MEMORANDUM

To: EPA

Subject: Olin Chemical Superfund Site - DAPL Extraction Alternatives v2.2

Date: 7/19/19

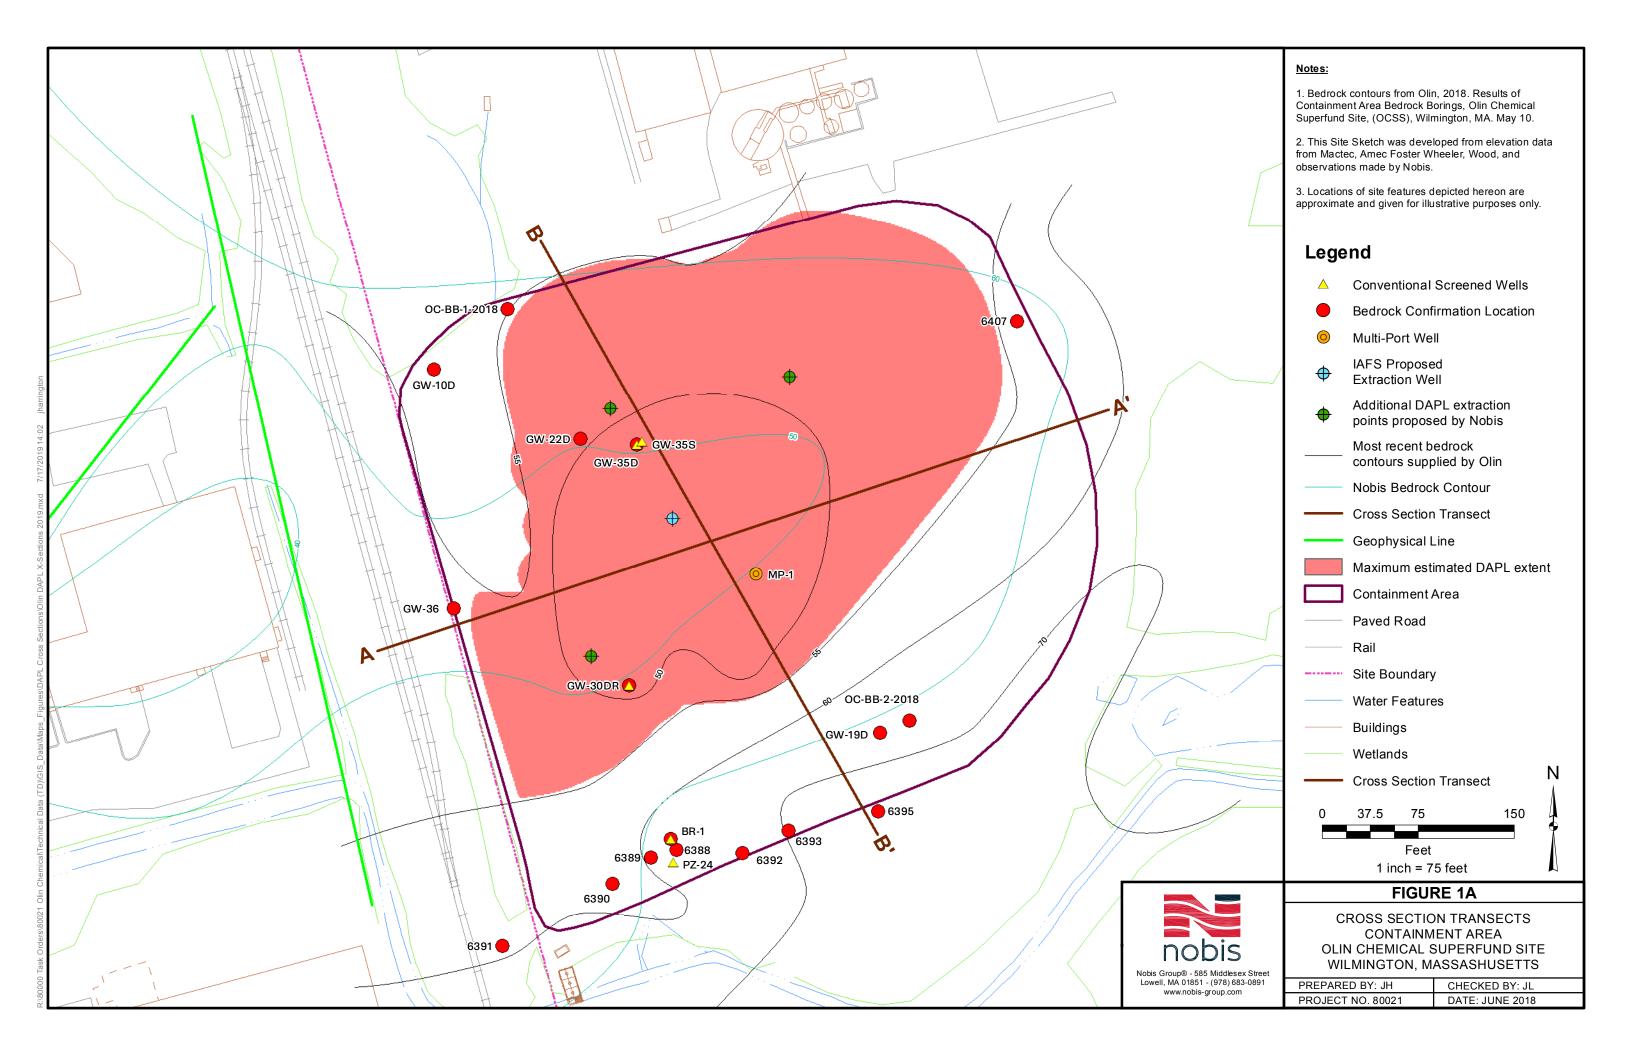
The IAFS provides one alternative for DAPL extraction in the Containment Area (Figure 1A). Olin proposes to install a single extraction well in the center of the presumed DAPL pool. This extraction well would be installed to the top of the bedrock surface, with a two-foot screen. Olin would install one induction logging well and one multi-level well close to the new extraction well.

- Few borings were advanced within the DAPL pool to confirm bedrock Olin installed bedrock confirmation borings around the slurry wall to support slurry wall design, but relatively few points were located within the DAPL pool.
- The configuration of the bedrock saddle at the eastern edge of the DAPL pool is not well defined.

Figure 1A shows the superimposed bedrock contours developed separately by Nobis and Wood. Both interpretations suggest considerable variation in potential bedrock topography. East-west and north-south cross-sections of the Containment Area DAPL pool are shown in Figure 1B and 1C, respectively.

As shown in Figure 1A, only one multi-port monitoring well (MP-1) is located within the 5-acre Containment Area. Five additional monitoring wells with 5 to 10-foot screens are located within the containment area, but the screen length does not allow for accurate evaluation of the DAPL elevation or chemistry.

At least two additional multi-port wells are needed northeast and west of MP-1 to provide chemical profiles with depth and to determine a more accurate DAPL volume. These locations may be revised based on the bedrock topography evaluation that should provide an updated understanding of the bottom of the DAPL pool.

Nobis recommends installing multiple extraction wells to maximize DAPL extraction rates and allow for even drawdown across the DAPL pool. These include a central DAPL extraction well at the deepest part of the DAPL pool (assumed to be the same central location recommended by Wood) and three auxiliary DAPL extraction wells located between the primary DAPL extraction well and the edge of the DAPL pool.

These locations would be adjusted based on revised bedrock topography determined in the PDI described in Section 1.2. Use of auxiliary extraction points would allow for relatively slow DAPL extraction at each point (assumed to be 0.25 gpm for planning purposes) and reduce the drawdown at any given point. The total extraction rate is assumed to be 1 gpm. Each extraction well would be paired with two multi-port monitoring wells at different distances to monitor extraction progress and the shape of the drawdown curve.

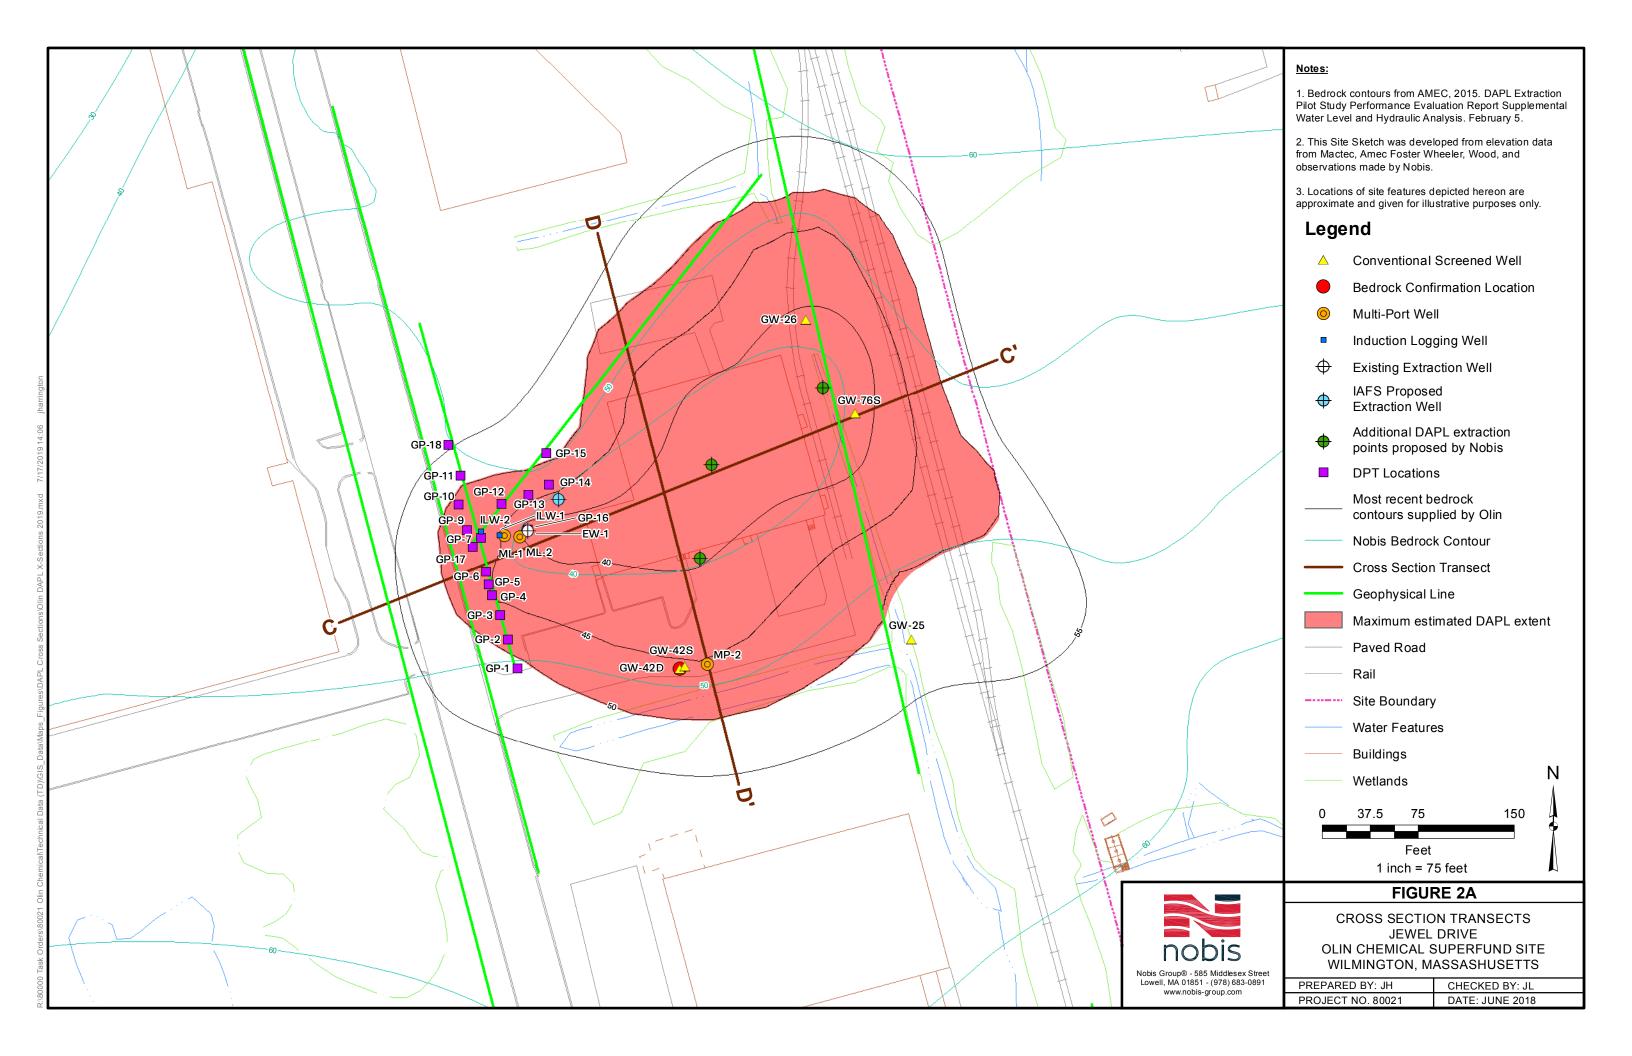
The IAFS (Wood, 2019) proposes replacing the existing DAPL extraction well with a new well adjacent to the current vault. New well construction would use a 2-foot screen instead of the current 5-foot screen (Figure 2A). The current extraction well may be converted to multilevel well or replaced with a new multi-level well.

The area around the building has been characterized using surface geophysics, direct-push technology (DPT) borings to tag bedrock, and multi-port and conventional monitoring wells, as shown in Figure 2A. However:

- The area immediately south of the building and within the building footprint has not been characterized.
- Bedrock has not been confirmed via coring except at GW-42D, south of the building.

As shown in Figure 2A, the multi-port wells at the OPWD DAPL pool are located at the western and southern edges of the DAPL pool. At least two multi-port wells are needed beneath the building and northeast of the building to provide chemical profiles with depth and to determine a more accurate DAPL volume. One of these multi-port wells should target the area of deepest bedrock based on the bedrock topography elevation described above.

Olin should install multiple extraction wells to maximize DAPL extraction rates and allow for even drawdown across the DAPL pool. In addition to Wood's proposed EW-2 replacement, Olin should install a DAPL extraction point at the lowest point in the basin (assumed to be beneath the center of the building). One or more angled extraction wells should be installed from outside the building to target the deepest concentrations if an extraction well cannot be installed directly beneath the building.

In addition, Olin should install auxiliary DAPL extraction wells between the edge of the DAPL pool and the central extraction point to minimize drawdown and provide flexibility with pumping rates. Suggested locations are shown in Figure 2A. Use of auxiliary extraction points would allow for relatively slow DAPL extraction at each point (0.25 gpm for planning purposes) and reduce the drawdown at any given point. The total extraction rate from all the proposed extraction points is assumed to be 1 gpm. Depending on the variability of the bedrock surface, it may be necessary to add a second extraction well to target the area beneath the building.

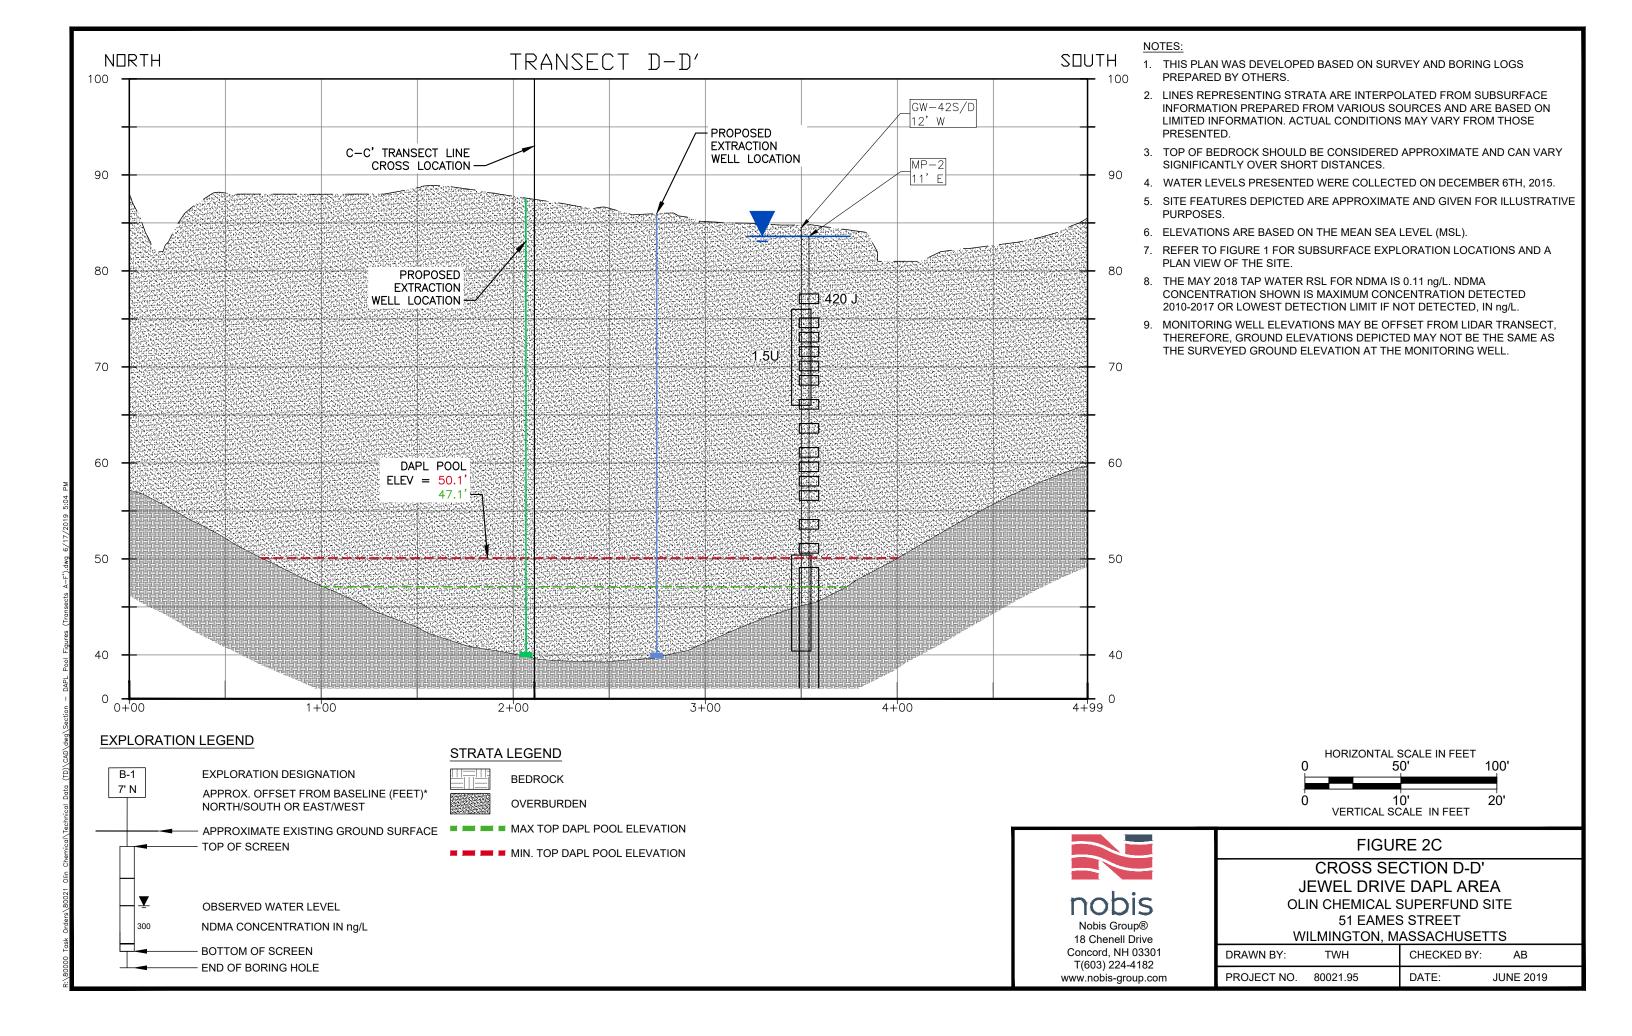
The IAFS (Wood, 2019) proposes DAPL extraction using a three extraction points in the Main Street DAPL pool (Figure 3A). The following subsections describe the IAFS alternative in more detail, discuss the data gaps and uncertainties associated with the Main Street DAPL pool area, and propose a revised alternative.

As shown in Figure 3A, the only multi-port well located within the Main Street DAPL pool (MP-3) is in the far northeast corner. It is unclear how much the DAPL pool elevation can be extrapolated from this point, given the size of the pool and the fact that MP-3 appears to be somewhat isolated from the rest of the pool. At least four additional multi-port monitoring wells should be installed to ensure coverage of the area: at the apparent low spot close to DP-11 in the southern portion of the DAPL pool; at the center of the DAPL pool (apparent low spot close to DP-5), at the downgradient bedrock depression that may be a conduit for DAPL migration (south of DP-14), and at the northeastern lobe of the DAPL pool south and southeast of DP-4.

The Main Street DAPL pool is significantly larger than the other pools, and other extraction points will be required in addition to the three extraction wells proposed by Wood. As described in Section 1.3 and Section 2.3, multiple extraction wells are required to allow for higher pumping rates overall while minimizing drawdown at any given location.

The extraction well locations and configuration may change after the more detailed bedrock topography investigations described above are completed. However, based on existing information, it is reasonable to assume that the bedrock lows associated with DPT data represent a trend of relatively low elevations. Therefore, two extraction wells should be installed between the two southern extraction wells proposed by Wood, with one extraction well installed west of the southernmost extraction well proposed by Wood (east of GW-59D/S) and an additional six extraction wells installed for full coverage in the northern portion of the DAPL pool.
